CITY PLANNING COMMISSION

1. Environmental Determination
2. Rezone 46.2+ vacant acres from R-1-A (Townhouse) to R-1 (Single Family)
3. Variance to create lots in excess of 160 ft. in depth
4. Subdivision Modification to create lots in excess of 160 ft. depth
5. Subdivision Map to waive sewer and water hook ups to lot A
6. Tentative Map (Northwind Wind Estates)

Southeast corner of Grace Avenue & Norwood Avenue

TENTATIVE MAP FOR
NORTHWIND ESTATES

TENTATIVE MAP

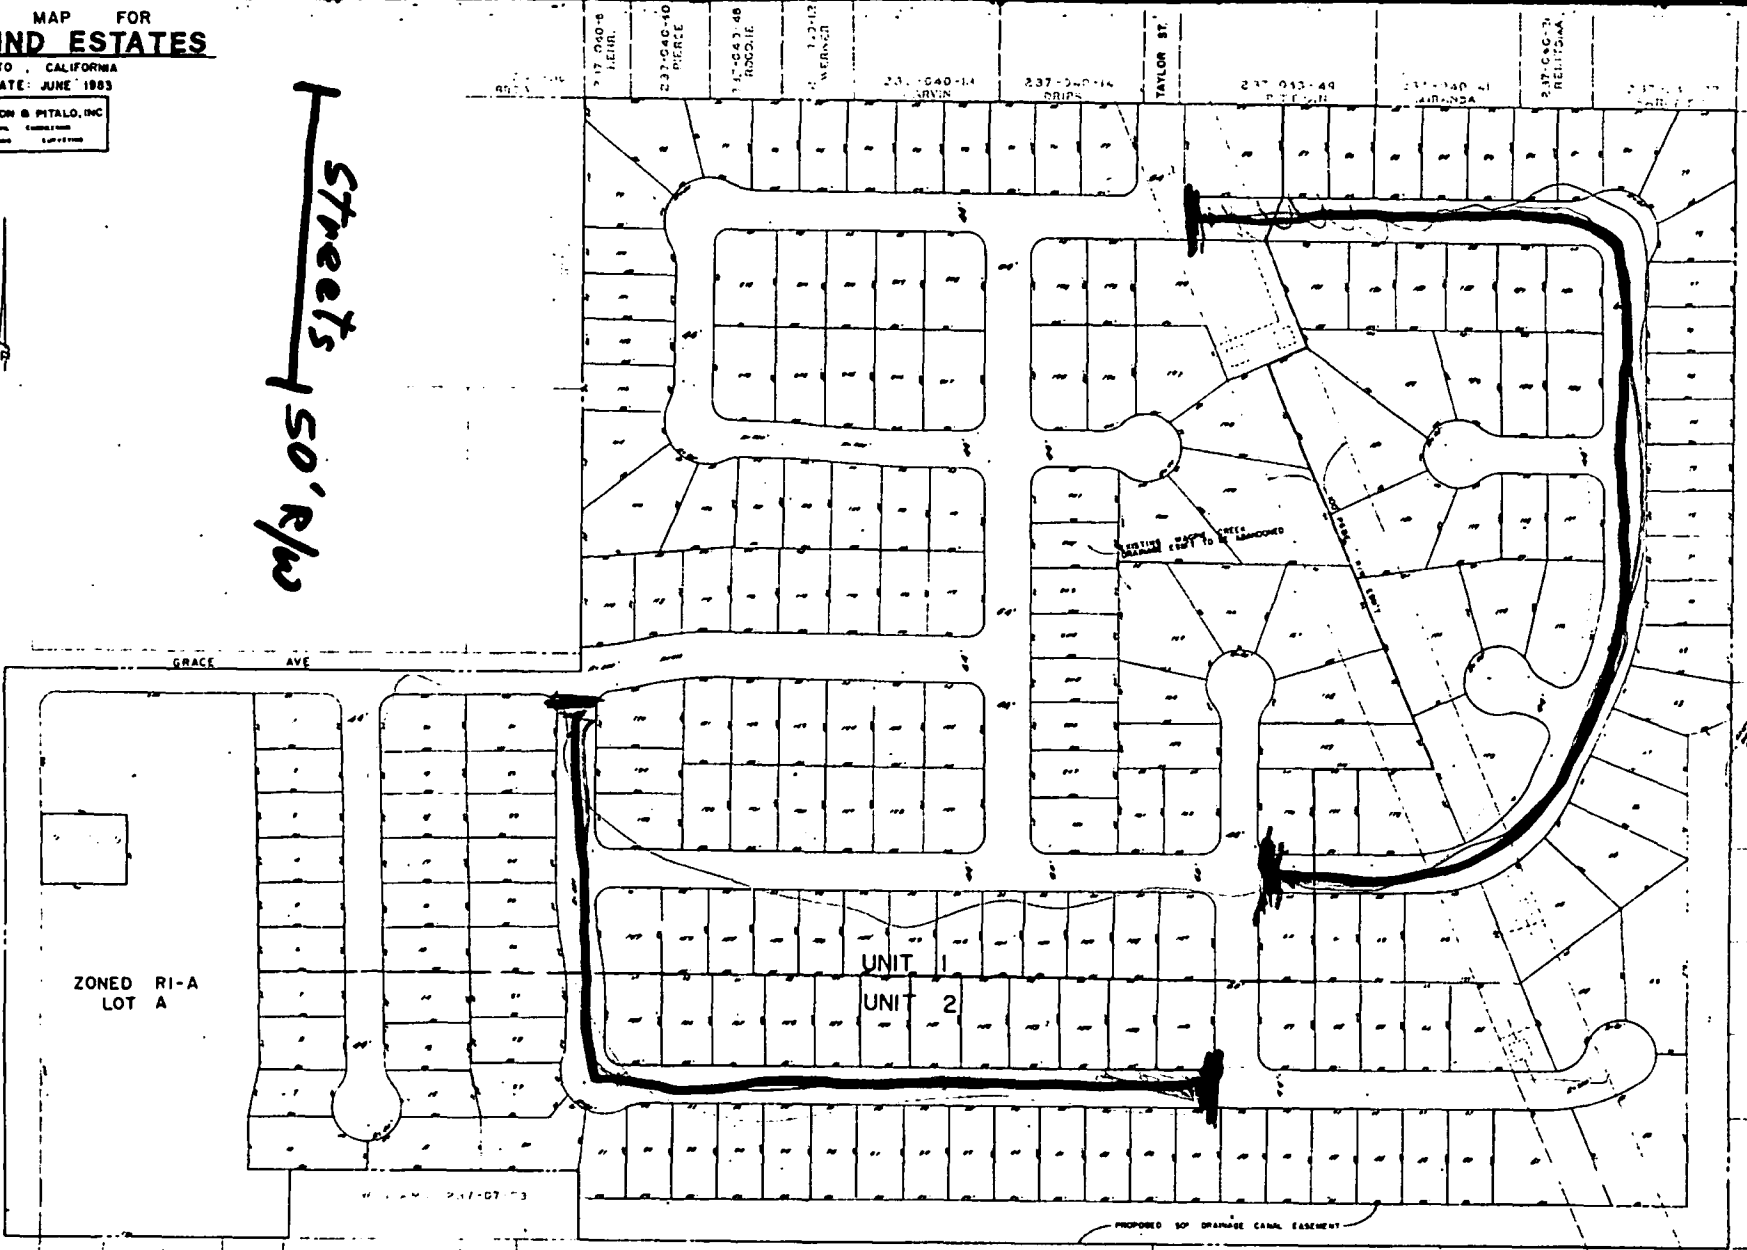
2. The applicant has proposed all interior street right-of-ways of 44 feet in width. The Subdivision Review Committee, however, recommends the widths be

*** increased to 50 for the perimeter streets (fronting lots 1130 and 1171). 21-45 and 60-88
Attached is a letter from Traffic Engineering indicating the reason for their recommendation.

3. The City Engineer requests that the final map be redrawn to indicate the portion of the subject site south of the proposed Magpie creek drainage canal, fronting on Bell Avenue, as a remainder, lot B.

5. A Subdivision Modification to create lots in excess of 160 feet in depth has been requested. Staff has no objection since the 100 foot wide PG&E easement crossing the subject site makes standard design difficult. A note should be placed on the final map indicating that lots 53 and 169 are for single family development only.

7. The subdivision achieves only 62% north/south lot orientation. The 80% requirement will, therefore, have to be met with a combination of lots and units situated on east/west oriented lots. Those lots and units which will meet solar access requirements should be designated on the final map.

16. Redesign ditch to eliminate right angles.
17. Place the following note on the final map: Lots 53 and 169 are for single family residences only.
18. Redraw the map to indicate the remainder, south of Magpie Creek drainage canal, fronting on Bell Avenue, as a remainder, Lot B.

- ** 20. *The south and west perimeter streets shall be 50-feet in width, Lots 21 thru 45.*
- ** 21. *The north and east perimeter streets shall be 50-feet in width, Lots 60 thru 88.*

TENTATIVE MAP

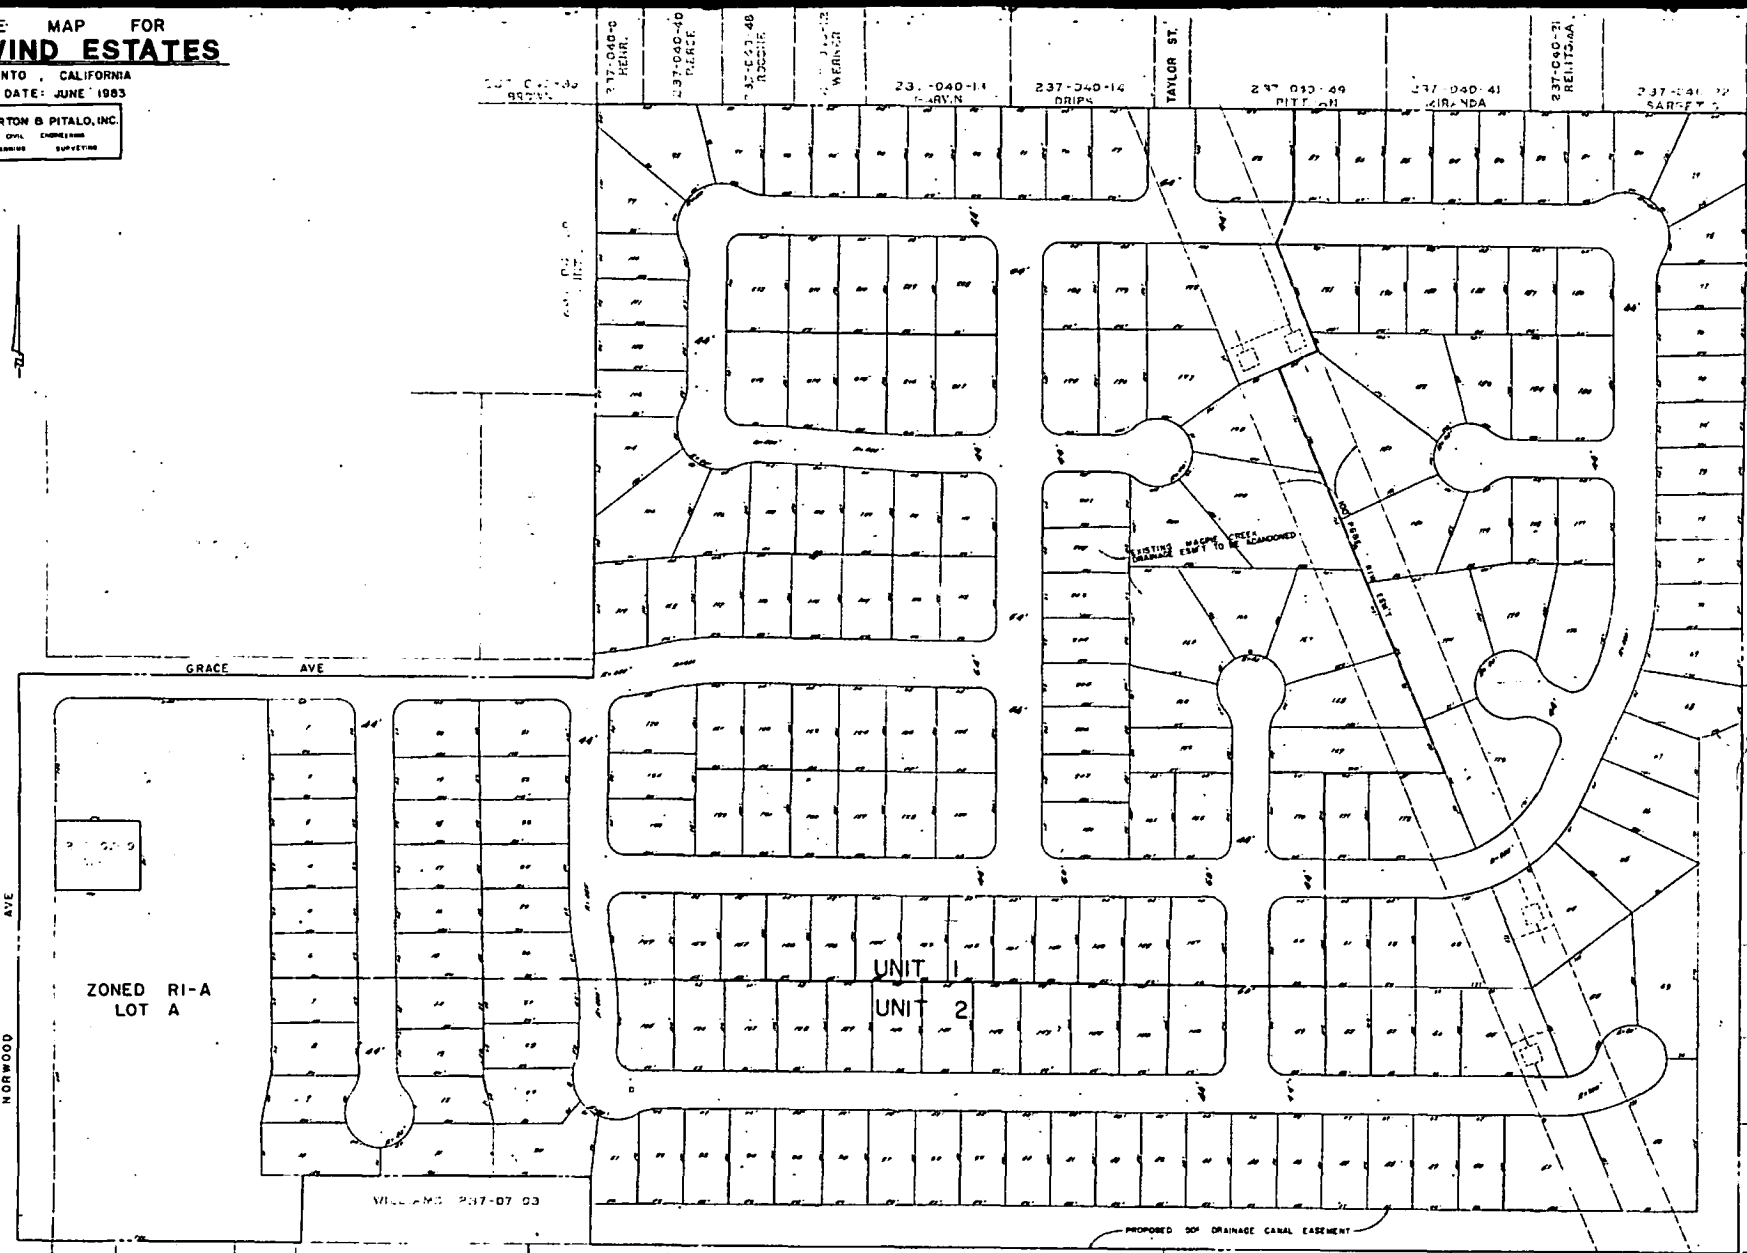
Streets 150 r/w
